Project Name: **BRW&S H2GO Administrative and Field Operations Complex (A+FO Complex)**
Adjacent to 146 Gregory Road, NE
Belville, NC 28451

Architect's Project Number: #342302

ADDENDUM NUMBER ONE

K1 FIRST FLOOR PLAN | NORTHWEST
SCALE: 1/8" = 1'-0"

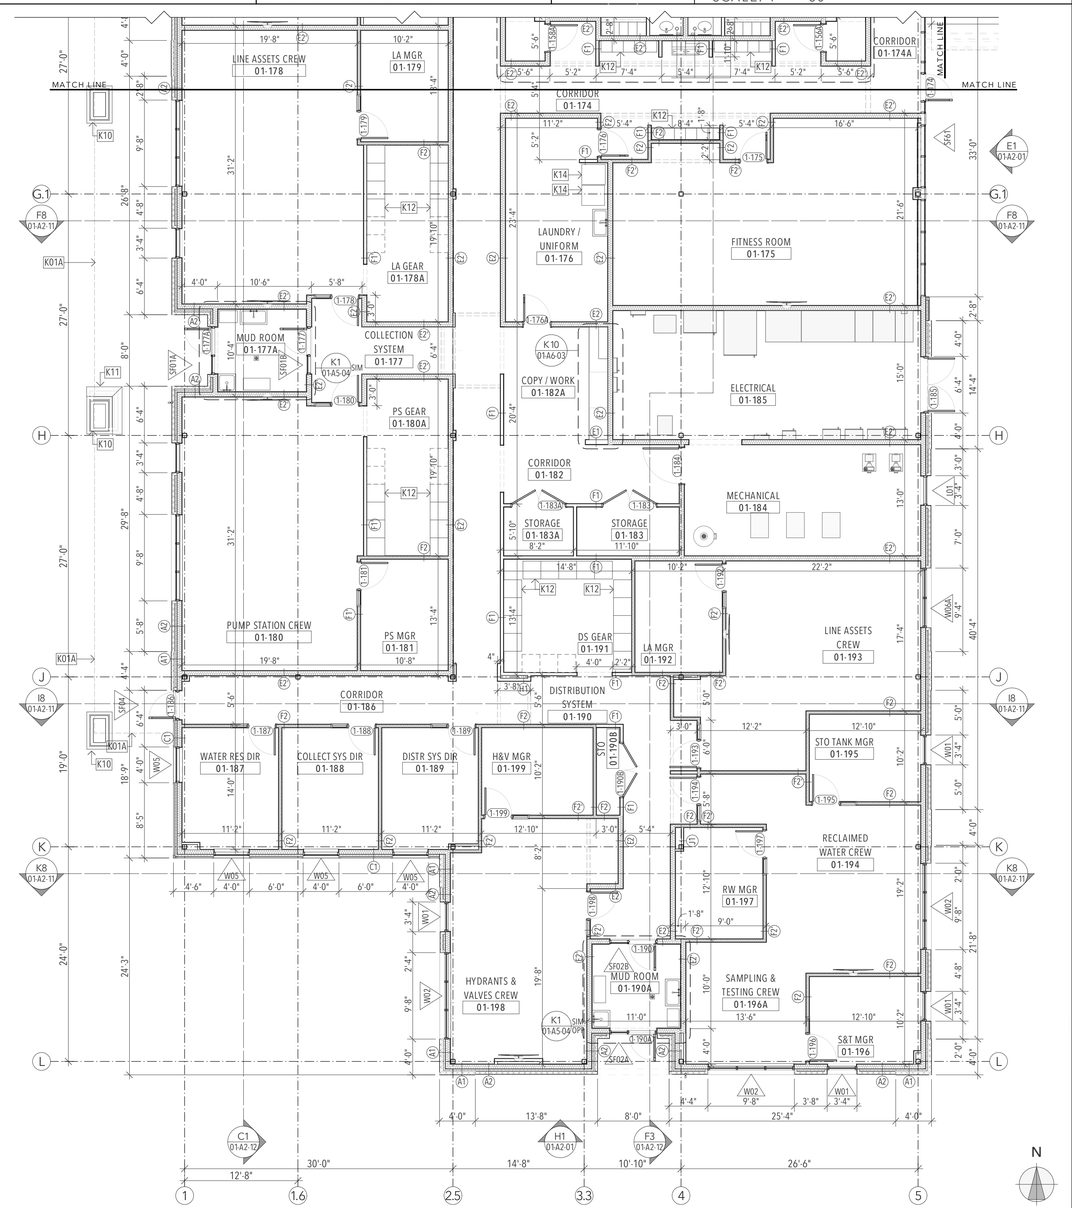
Change 1 [Cloud Marker A1-1]: Automatic Door Updates

- **01-A1-01a - FIRST FLOOR PLAN | WEST**: Keyed Notes Added at push pad locations.
- **01-A1-01b - FIRST FLOOR PLAN | EAST**: Keyed Notes Added at push pad locations.
- **01-A7-01 - DOOR AND FRAME SCHEDULES AND DETAILS**: Scheduled Accessories updated to remove HCPP.

K1 FIRST FLOOR RCP | NORTHWEST
SCALE: 1/8" = 1'-0"

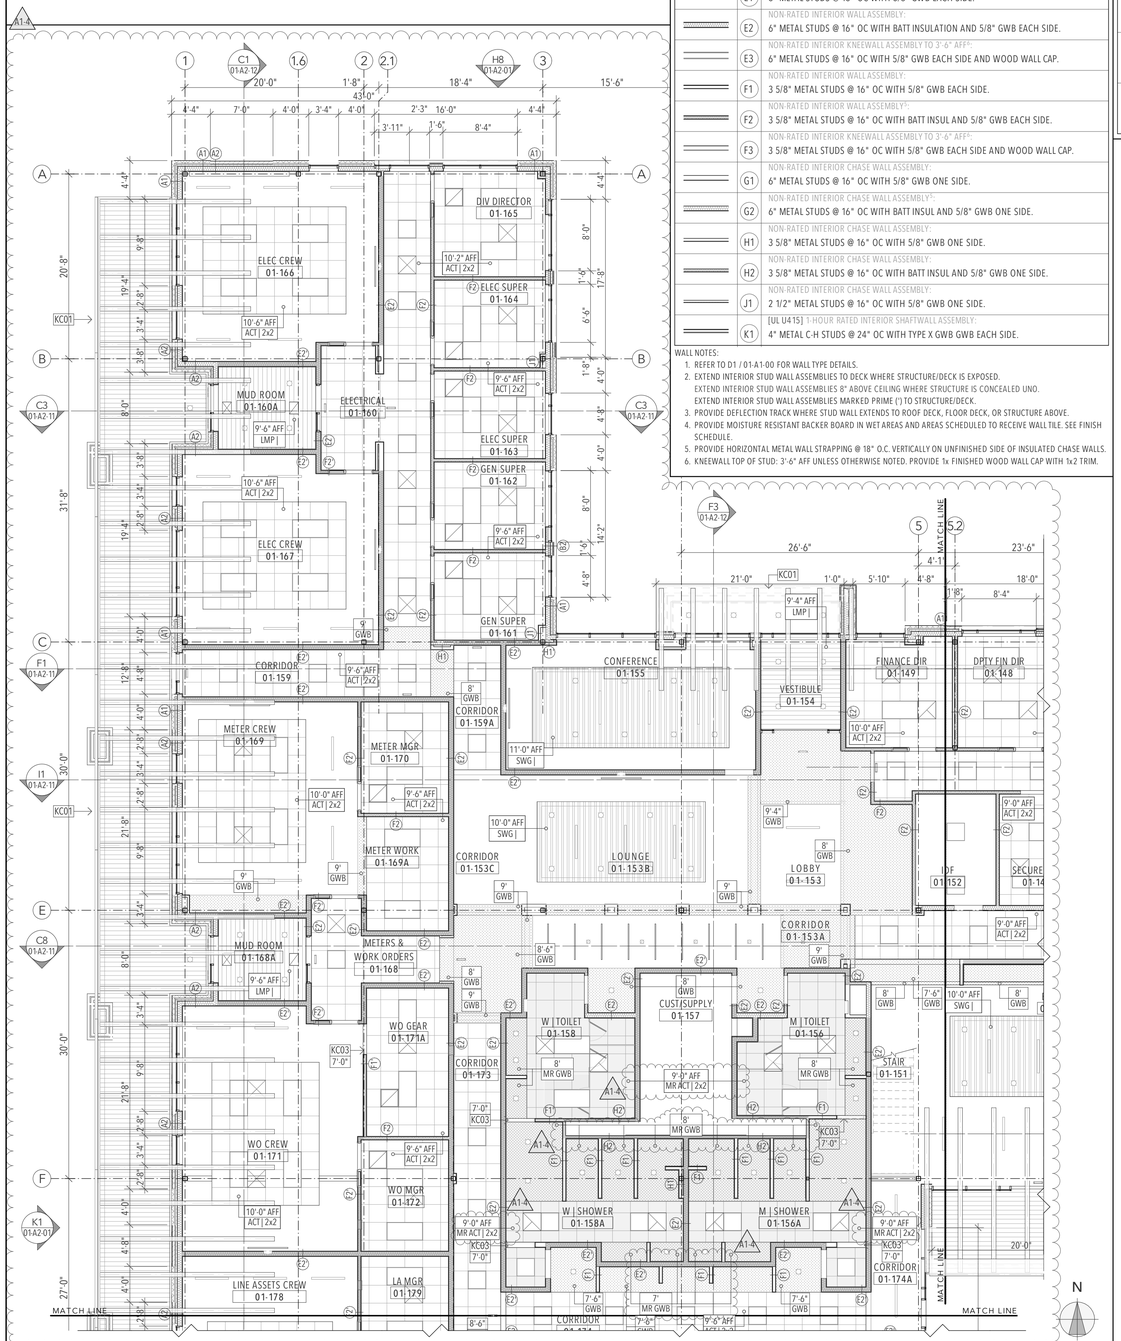
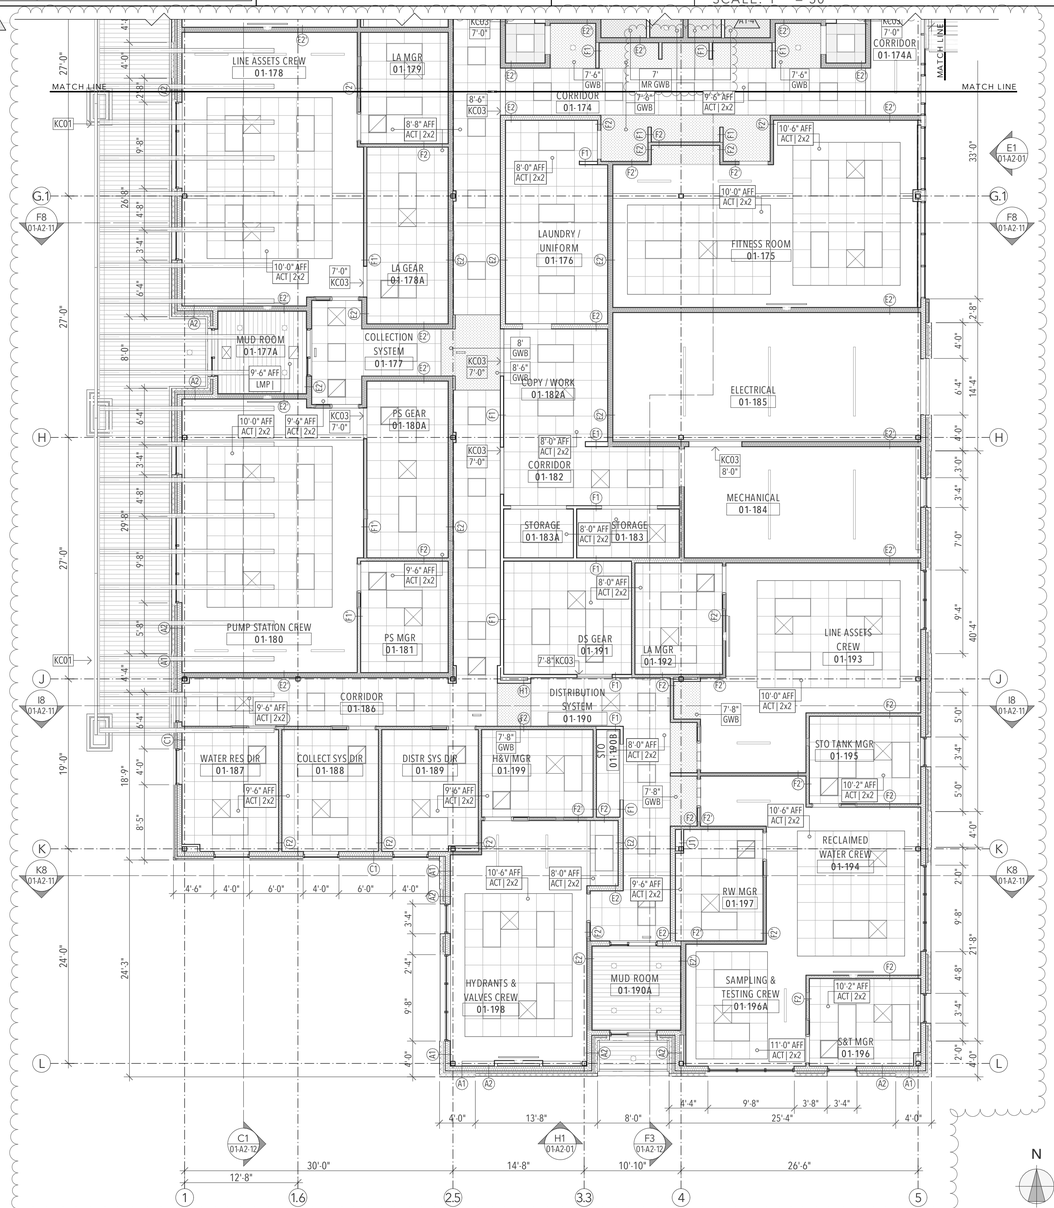
Change 4 [Cloud Marker A1-4]: Reflected Ceiling Plan Corrections

- **01-A1-11a FIRST FLOOR REFLECTED CEILING PLANS | WEST**: Missing ceiling labels added. Ceiling graphic representations corrected.
- **01-A1-11b FIRST FLOOR REFLECTED CEILING PLAN | EAST**: Ceiling graphic representations corrected.
- **01-A1-12a SECOND FLOOR REFLECTED CEILING PLANS | WEST**: Ceiling graphic representations corrected.
- **01-A1-12b SECOND FLOOR REFLECTED CEILING PLAN | EAST**: Plan replaced with correct ceiling plan.

K1 | SECOND FLOOR RCP | NORTHWEST
SCALE: 1/8" = 1'-0"

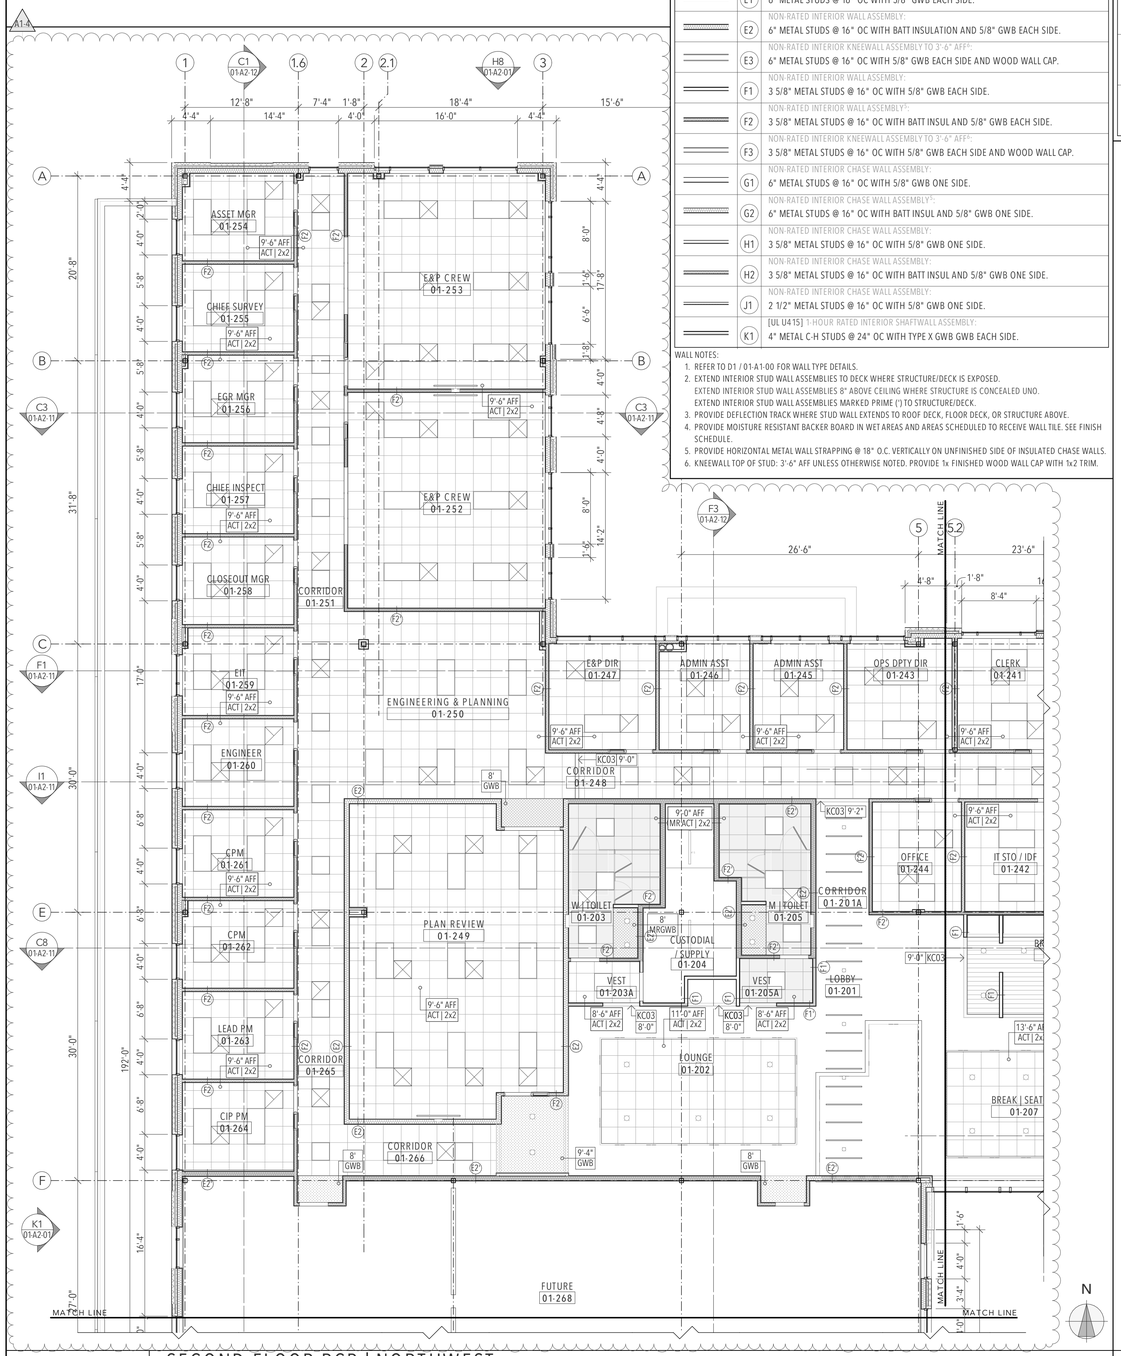
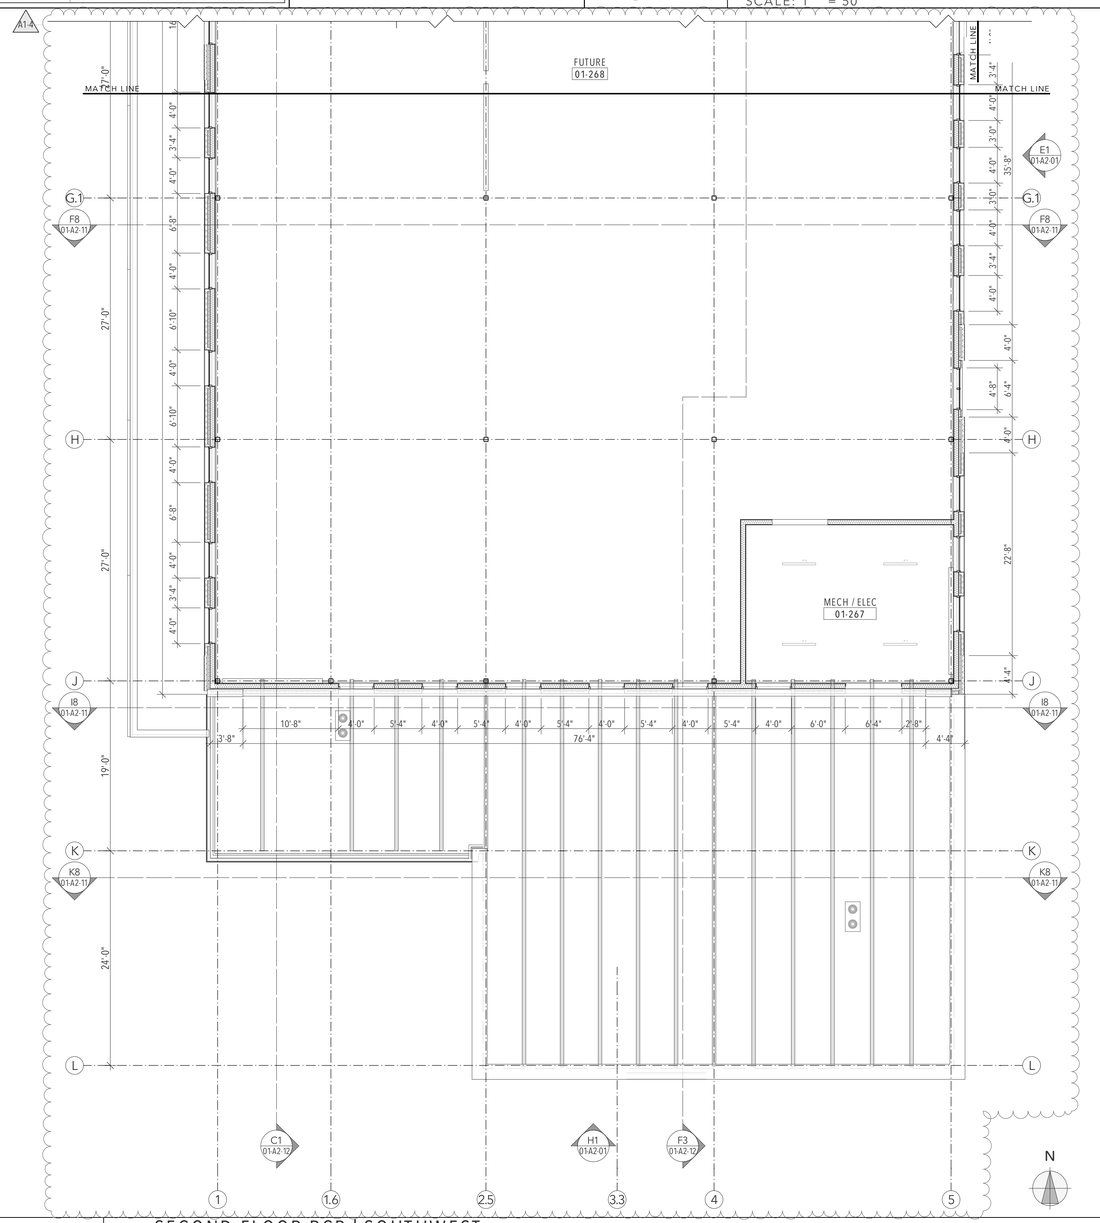
Print/display issues corrected for MR GWB, MR ACT, and standard GWB ceiling graphic representations. Second Floor Reflected Ceiling Plan | East corrected.

A1-x
01-A5-11

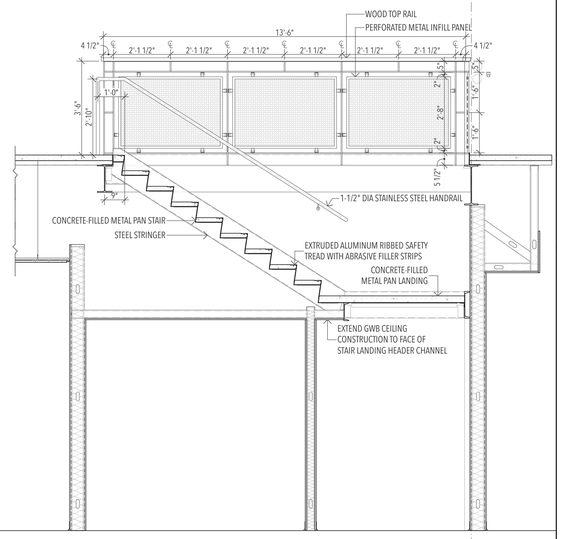
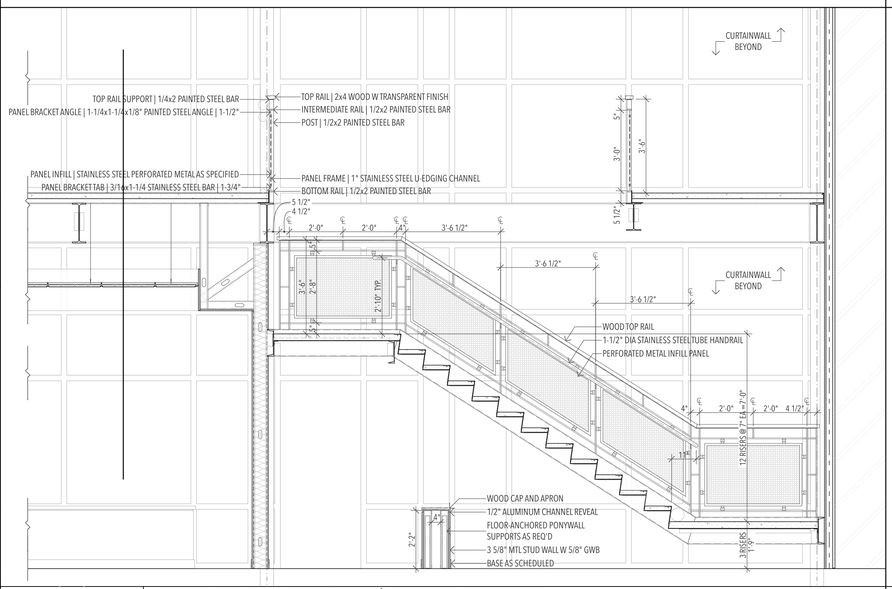
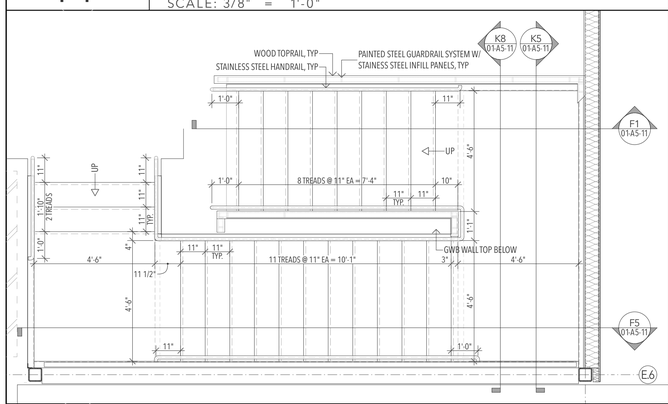
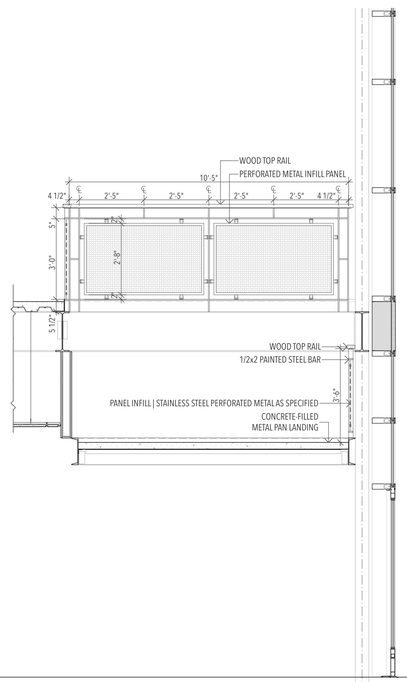
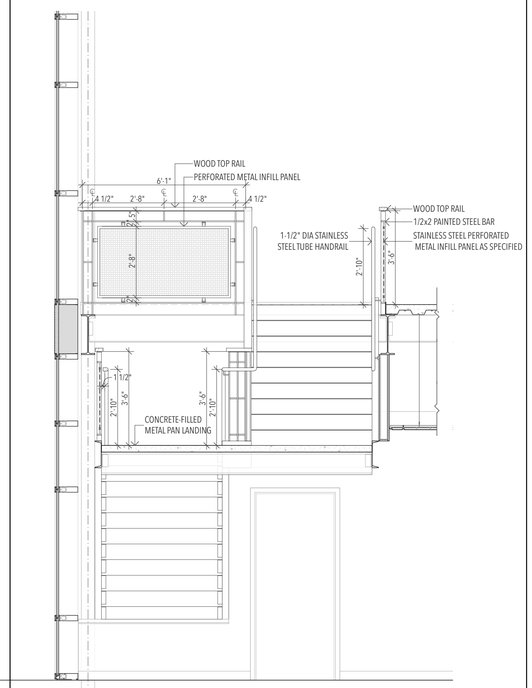
Change 2 [Cloud Marker A1-2]: Stair and Railing Drawing Updates

Stair 01-121 and Stair 01-151 enlarged plans and details added.

- **01-A1-01a - FIRST FLOOR PLAN | WEST**: Detail key marker reference updated.
- **01-A1-01b - FIRST FLOOR PLAN | EAST**: Detail key marker reference updated.
- **01-A5-11 - ENLARGED STAIR PLANS AND DETAILS**: **NEW SHEET**
- **01-A5-12 - ENLARGED STAIR PLANS AND DETAILS**: **NEW SHEET**
